Item ID: D212-664-201 Accept *N900040100* Setup Start *NS1*
 Revision ID: Stop *NS2*
 Item Name: Aft Crosstube - High
 Start Date: 11/19/13 Start Qty: 1.00 *1* Cust Item ID:
 Required Date: 12/03/13 Req'd Qty: 1.00 *1* Customer:
 Reference:

Draw Nbr	Revision Nbr
D212-664-241	Rev D (DEO)
DSI9563	B

DRAWING NO. D212-664-241	TITLE CROSSTUBE ASSY (205/212 HI AFT)	REV. D	DART AEROSPACE LTD ENGINEERING ORDER		D.E.O. NO. D212-664-241-D-1	SHEET NO. SHEET 1 OF 2	SCALE NTS
DRAWN	CHECKED	MFG. APPR.	APPROVED	DE APPR.			
DATE 11.04.07	DATE 11.04.11	DATE 11.04.12	DATE 11/04/12	DATE 11.04.12

FIGURE 1: SUPPORT INSTALLATION

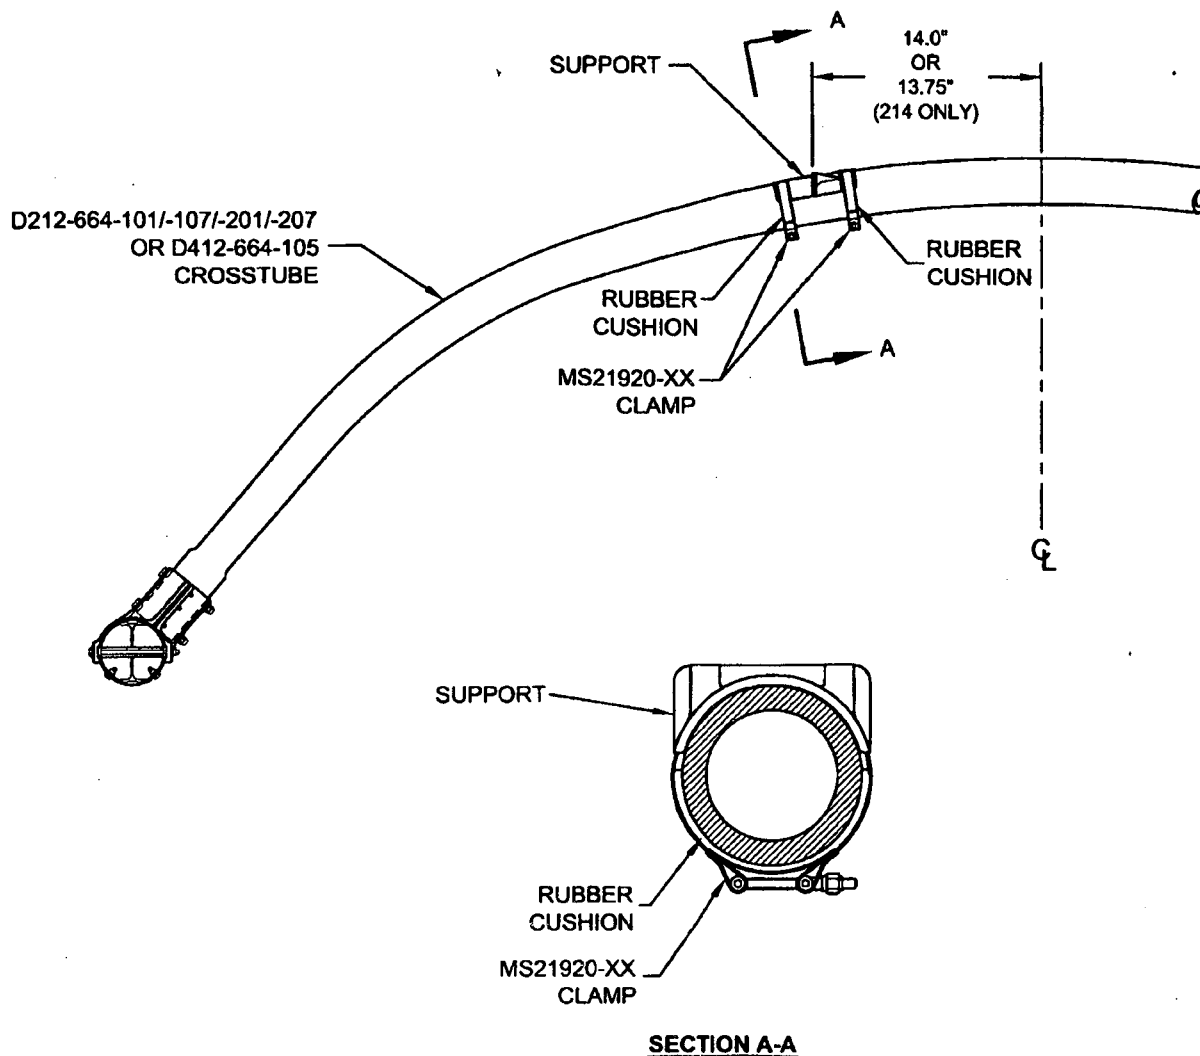
For the crosstubes listed above, section 32.4 of ICA-D212-664 is amended as follows. Use Figure 1 of this service instruction and Figures 32-2 to 32-9 of ICA-D212-664 for further reference. For crosstubes of an earlier change number, it is recommended that if the supports are removed, the supports should be reinstalled using the procedure listed below.

- 32.4.1 Locate the area on the crosstube for installation of support (see Figure 1 of this service instruction). For D212-664-101/-107/-201/-207 and D412-664-105 crosstubes, the outward face of the support tabs should be 14.0" (355mm) from the crosstube center for 204/205/210/412/UH-1 aircraft. For installation on 214B/B-1 aircraft, the outward face of the support tabs should be 13.75" (349mm). Ensure paint finish of crosstube is intact; touch up as required per Chapter 5 (5.3.9) of ICA-D212-664.

- 32.4.2 If present, remove any paint/primer on bottom of supports. Abrade mating surfaces of support and crosstube with 400-grit sandpaper. Saturate a clean cloth with MEK or 4105S Wash'n'Wipe Degreaser or equivalent and wipe until there is no residue.

- 32.4.5 Apply a 0.04" to 0.07" thick layer of Proseal 890 Class B or AMS-S-8802 Class B sealant underneath applicable support and install support as shown in Figure 1 of this service instruction.

- 32.4.6 Install the clamps opposite to crosstube support as shown in section A-A of Figure 1. Install rubber cushions underneath each clamp around the bottom circumference of the crosstube up to the crosstube centerline. Torque clamps 80-100 in-lb (9.0-11.3 Nm). It is acceptable to use smaller or larger sized MS21920-XX clamps than those listed in ICA-D212-664, ensure that after torquing the clamps per this instruction, the nuts are in safety but not bottomed out

**D212-664-241-241B
ASSEMBLY DETAIL**

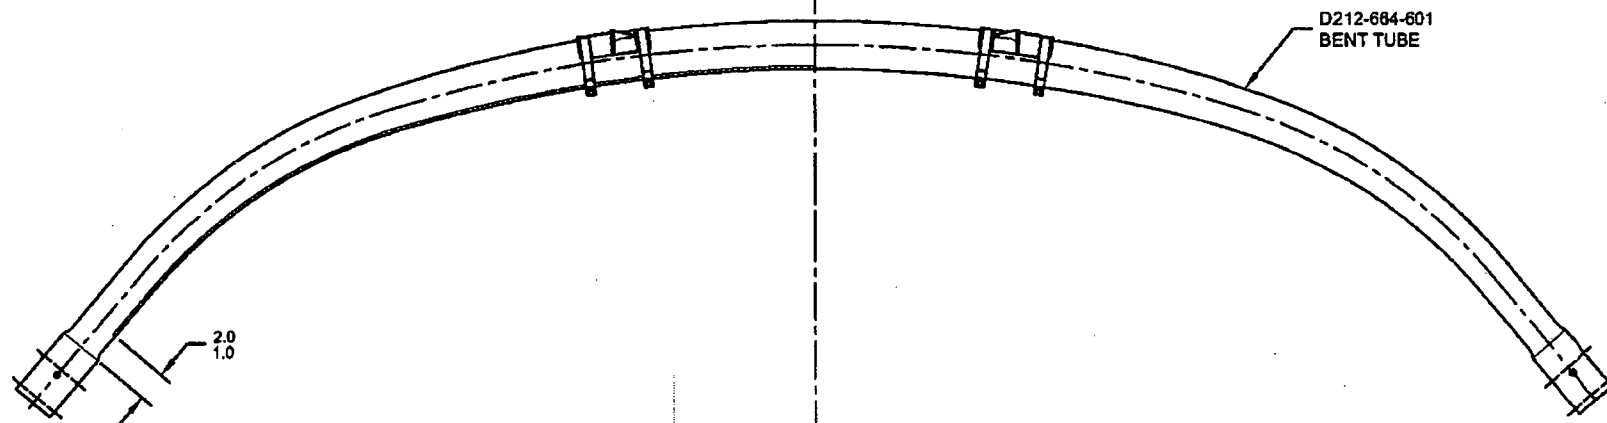
ADD AN INSPECTION WINDOW TO UNDERSIDE OF CROSSTUBE.

NOTES 2 OF SHEET 1 IS AMENDED AS FOLLOWS:

- 2) FINISH: CHEMICAL CONVERSION COAT PER DART QSI 005 4.1
PRIME INSIDE AND OUTSIDE PER DART QSI 005 4.2
MASK UNDERSIDE OF CROSSTUBE AS SHOWN (HATCHED AREA) AND
PAINT OUTSIDE PER DART QSI 005 4.2
REMOVE MASKING AND APPLY CLEAR COAT

MASK AREA PRIOR TO PAINTING,
REMOVE MASKING AFTER PAINT
AND APPLY CLEAR COAT
